Appendix C

Agency Coordination

RE: SH 82/Grand Avenue Bridge Environmental Assessment

RE: Grand Avenue Bridge Environmental Assessment

Figure 1 - Modified Area of Potential Effect and 5GF1661.7 boundary

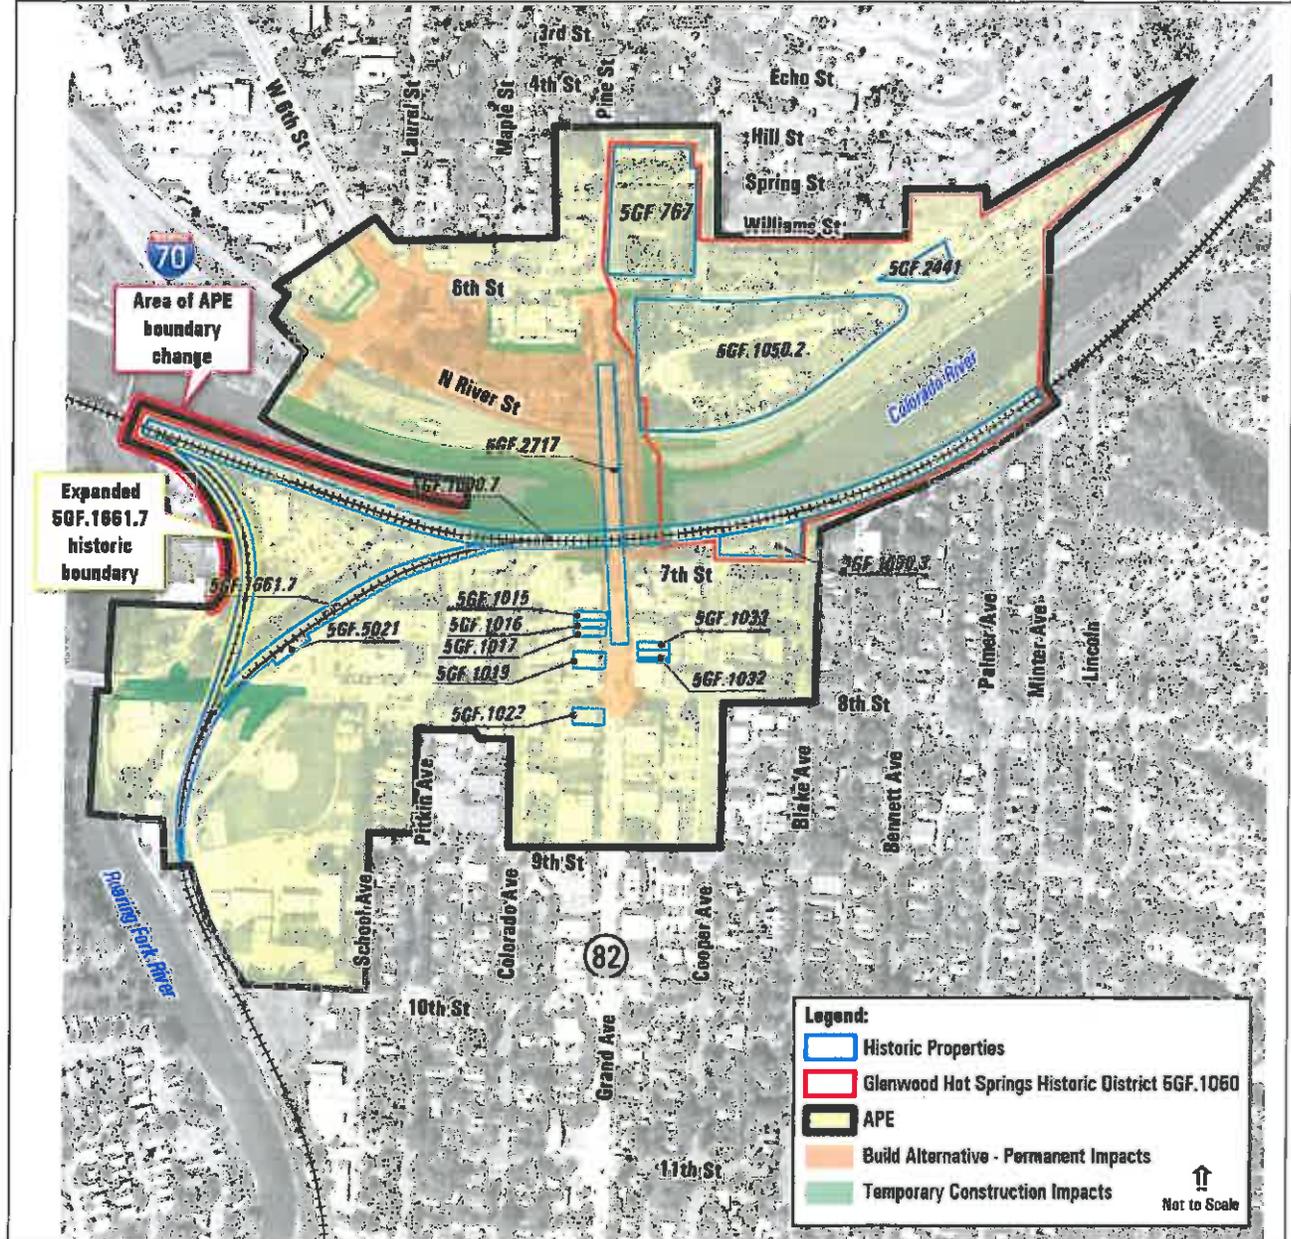
The APE boundary outlined in our March 2014 letter has been extended to the west to fully encompass the historic boundary for the Denver & Rio Grande Railroad (5GF1000.7). This revision was included in the Environmental Assessment (EA) without formal consultation with your office, but the change is minor and involves including a part of the documented resource that was previously excluded from the boundary. The APE boundary was also revised to encompass the extended historic boundary for the Denver & Rio Grande Railroad-Aspen Branch (5GF1661.7). With this change, the APE now encompasses the area east of the resource that was not previously included. This area will not be impacted by the project, but is included in the APE to allow for a contiguous APE boundary. The area contains the City of Glenwood Springs' former wastewater treatment plant, which is planned for redevelopment. A revised APE map is included herewith, and the updated areas are highlighted.

To be consistent with the revised APE, the historic boundary for the Denver & Rio Grande Railroad-Aspen Branch (5GF1661.7) was modified to better reflect the resource description on the site form that includes the connection to the westbound Denver & Rio Grande Railroad mainline. The updated site form and maps for that resource are attached.

Figure 2 - Temporary and Permanent Easements

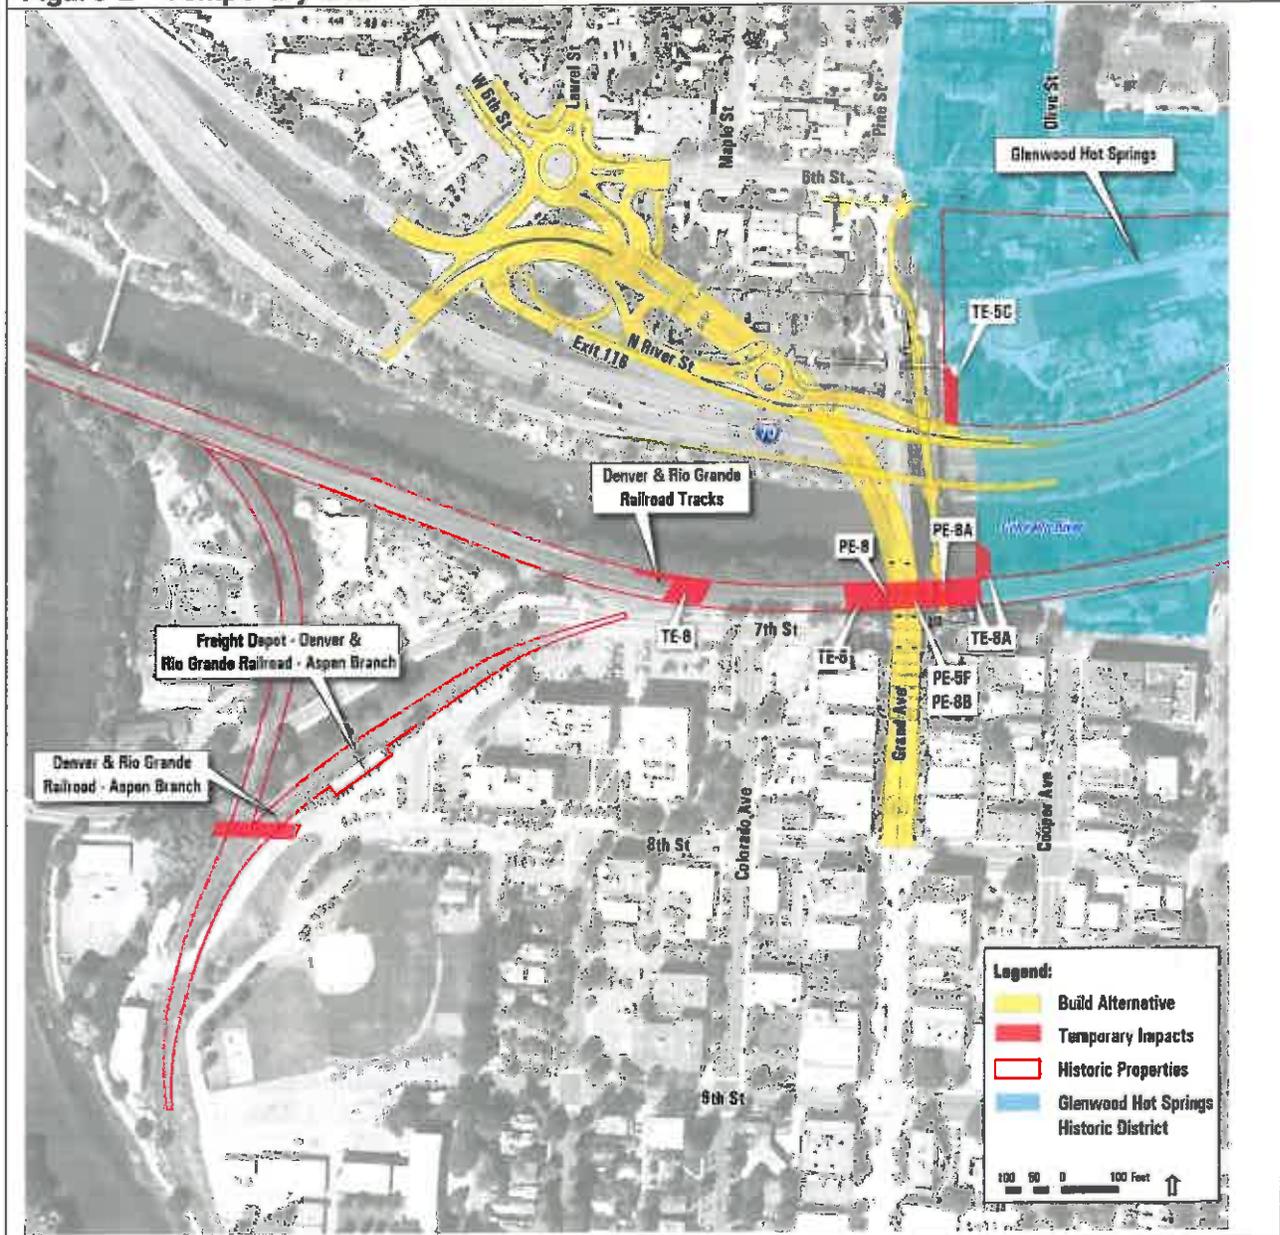
Denver & Rio Grande Railroad (5GF1000.7): In the March 2014 consultation, there was a single permanent aerial easement (0.01 acre) to the railroad. Also, the August 2014 consultation described a temporary aerial easement to the railroad. However, based on updated right-of-way information, neither of these easements would be considered "aerial." This does not change the effects; impacts in locations previously designated as aerial would still be limited to above-ground work. Further, our March 2014 consultation stated that three temporary easements totaling approximately 0.15 acre would be required on the railroad west of the bridges. Now only two temporary easements are required west of the bridges, and total approximately 0.21 acre. The use of these easements is the same as described in our previous consultation, which is to provide access to construction areas.

Three additional permanent easements will be required on the railroad that were not included in the previous consultation. One area is approximately 0.115 acre located under the existing highway bridge. Although this involves one area, a permanent easement is required from the two parties disputing property ownership, resulting in two permanent easements for this one area. The third permanent easement is approximately 0.037 acre located under the existing pedestrian bridge. These three permanent easements are needed to provide access to CDOT for ongoing bridge maintenance. In summary, there are now a total of four permanent easements (including two permanent easements for one area) and three temporary easement locations on the railroad, as noted in Table 1. These permanent and temporary easements will

Modifications made to permanent and temporary easements for 5GF1050, 5GF1050.2 and 5GF1000.7 described in Table 1 are minor, and the project would still result in *no adverse effect* to these resources. Easements listed in Table 1 are shown on Figure 2.

Figure 1 - Modified Area of Potential Effect and 5GF1661.7 boundary

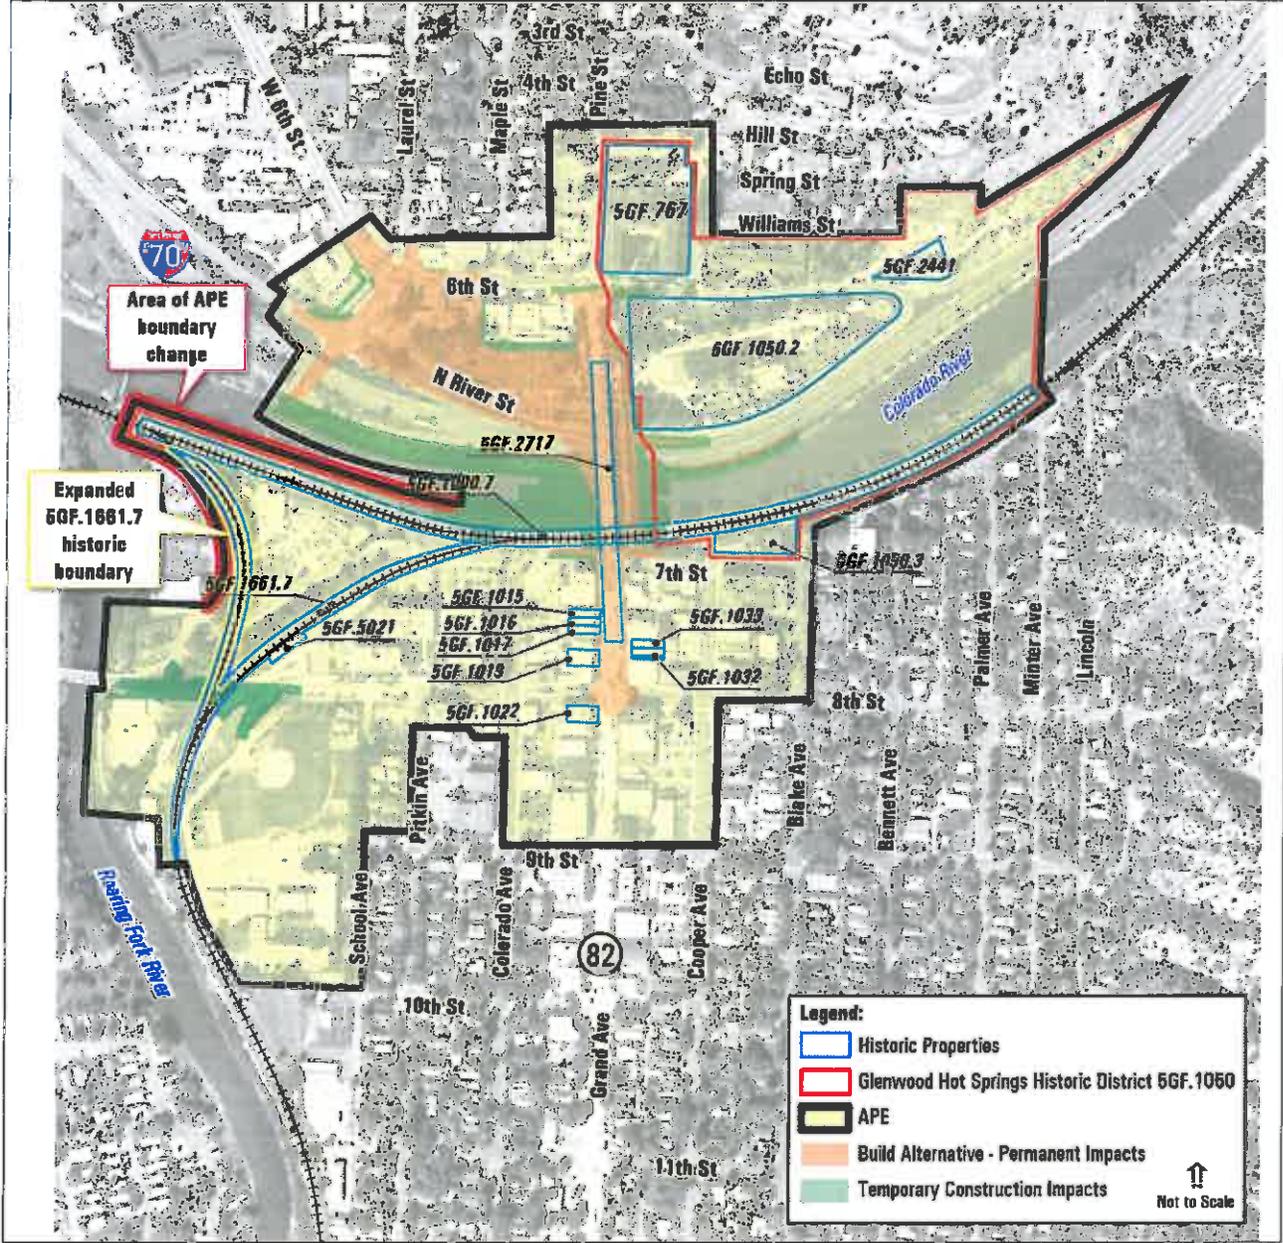
The APE boundary outlined in our March 2014 letter has been extended to the west to fully encompass the historic boundary for the Denver & Rio Grande Railroad (5GF1000.7). This revision was included in the Environmental Assessment (EA) without formal consultation with SHPO and the consulting parties, but the change is minor and involves including a part of the documented resource that was previously excluded from the boundary. The APE boundary was also revised to encompass the extended historic boundary for the Denver & Rio Grande Railroad-Aspen Branch (5GF1661.7). With this change, the APE now encompasses the area east of the resource that was not previously included. This area will not be impacted by the project, but is included in the APE to allow for a contiguous APE boundary. The area contains the City of Glenwood Springs' former wastewater treatment plant, which is planned for redevelopment. A revised APE map is included herewith, and the updated areas are highlighted.

To be consistent with the revised APE, the historic boundary for the Denver & Rio Grande Railroad-Aspen Branch (5GF1661.7) was modified to better reflect the resource description on the site form that includes the connection to the westbound Denver & Rio Grande Railroad mainline. The updated site form and maps for that resource are attached.

Figure 2 - Temporary and Permanent Easements

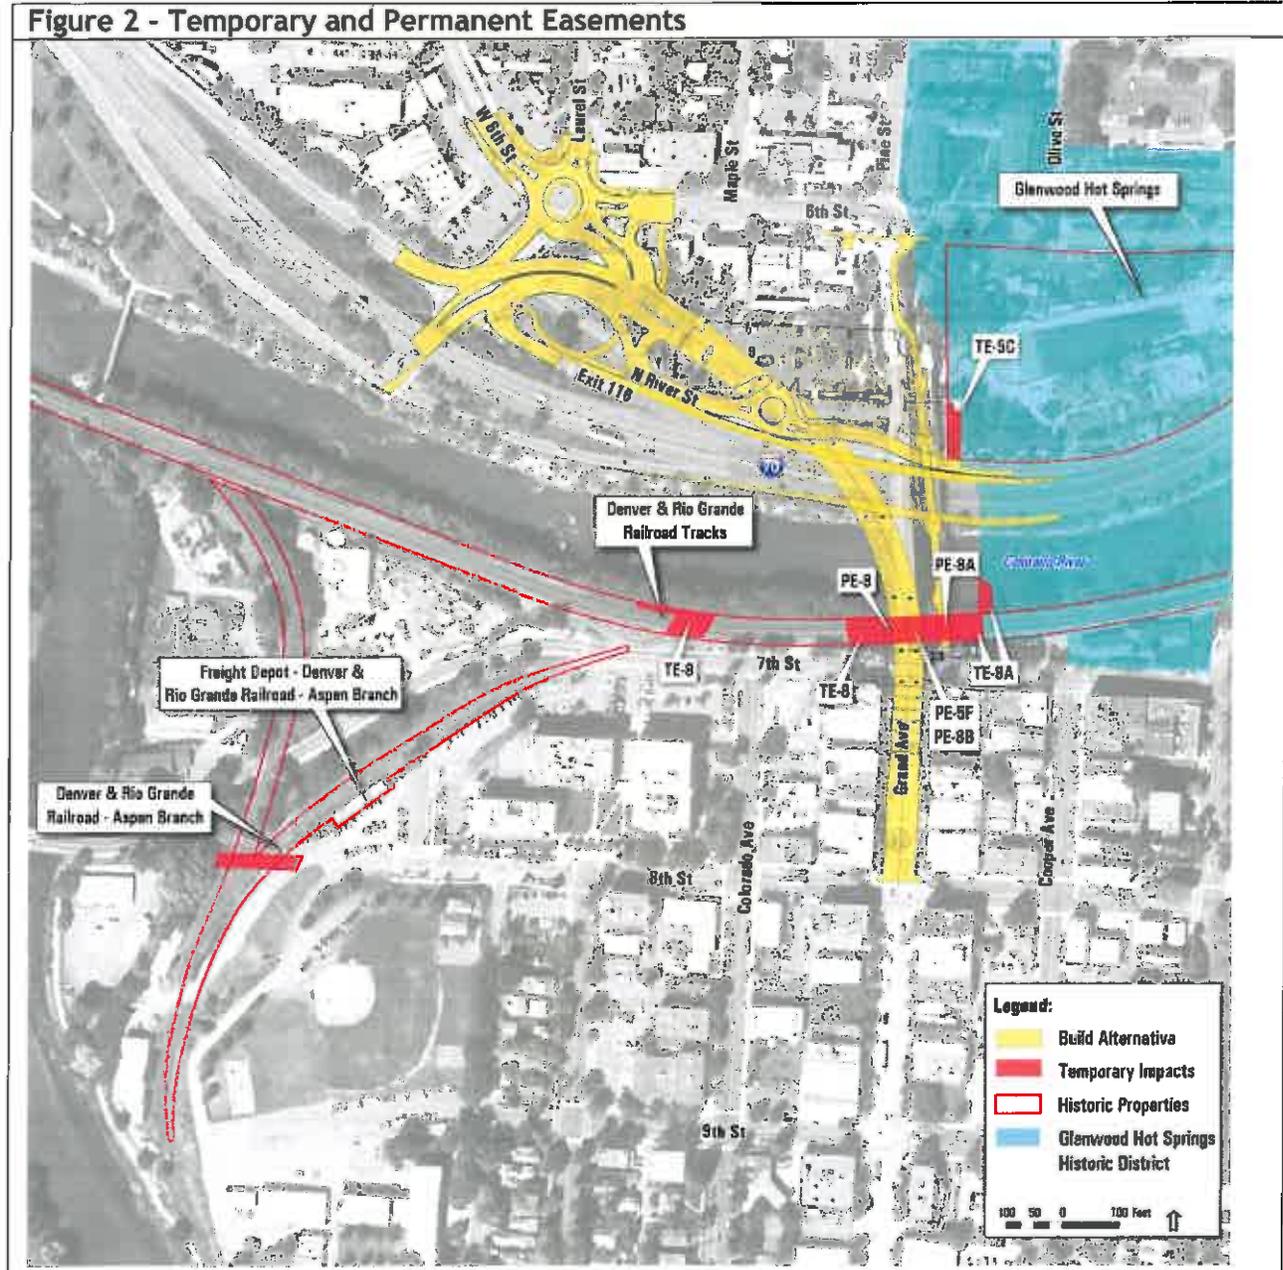
Denver & Rio Grande Railroad (5GF1000.7): In the April 2014 consultation, there was a single permanent aerial easement (0.01 acre) to the railroad. Also, the August 2014 consultation described a temporary aerial easement to the railroad. However, based on updated right-of-way information, neither of these easements would be considered “aerial.” This does not change the effects; impacts in locations previously designated as aerial would still be limited to above-ground work. Further, our April 2014 consultation stated that three temporary easements totaling approximately 0.15 acre would be required on the railroad west of the bridges. Now only two temporary easements are required west of the bridges, and total approximately 0.21 acre. The use of these easements is the same as described in our previous consultation, which is to provide access to construction areas.

Three additional permanent easements will be required on the railroad that were not included in the previous consultation. One area is approximately 0.115 acre located under the existing highway bridge. Although this involves one area, a permanent easement is required from the two parties disputing property ownership, resulting in two permanent easements for this one area. The third permanent easement is approximately 0.037 acre located under the existing pedestrian bridge. These three permanent easements are needed to provide access to CDOT for ongoing bridge maintenance. In summary, there are now a total of four permanent easements (including two permanent easements for one area) and three temporary easement locations on the railroad, as noted in Table 1. These permanent and temporary easements will not alter the qualities of significance of the railroad and a finding of *no adverse effect* is appropriate for this resource.

Modifications made to permanent and temporary easements for 5GF1050, 5GF1050.2 and 5GF1000.7 described in Table 1 are minor, and the project would still result in *no adverse effect* to these resources. Easements listed in Table 1 are shown on Figure 2.

Figure 1 - Modified Area of Potential Effect and 5GF1661.7 boundary

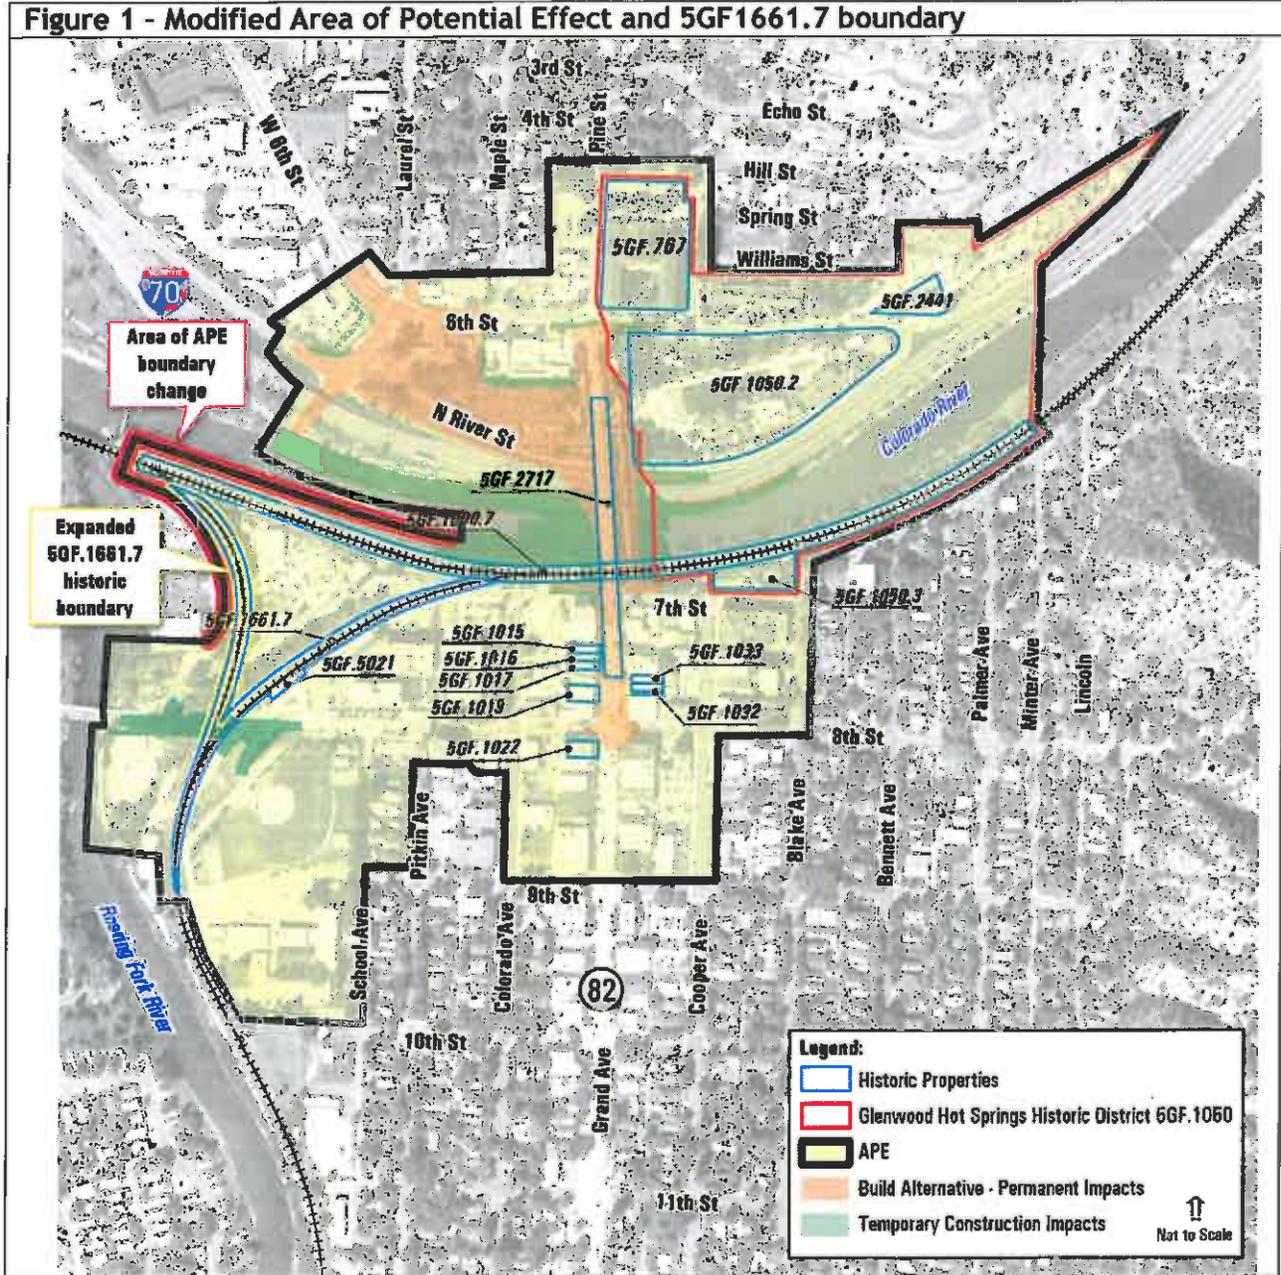
The APE boundary outlined in our March 2014 letter has been extended to the west to fully encompass the historic boundary for the Denver & Rio Grande Railroad (5GF1000.7). This revision was included in the Environmental Assessment (EA) without formal consultation with SHPO and the consulting parties, but the change is minor and involves including a part of the documented resource that was previously excluded from the boundary. The APE boundary was also revised to encompass the extended historic boundary for the Denver & Rio Grande Railroad-Aspen Branch (5GF1661.7). With this change, the APE now encompasses the area east of the resource that was not previously included. This area will not be impacted by the project, but is included in the APE to allow for a contiguous APE boundary. The area contains the City of Glenwood Springs' former wastewater treatment plant, which is planned for redevelopment. A revised APE map is included herewith, and the updated areas are highlighted.

To be consistent with the revised APE, the historic boundary for the Denver & Rio Grande Railroad-Aspen Branch (5GF1661.7) was modified to better reflect the resource description on the site form that includes the connection to the westbound Denver & Rio Grande Railroad mainline. The updated site form and maps for that resource are attached.
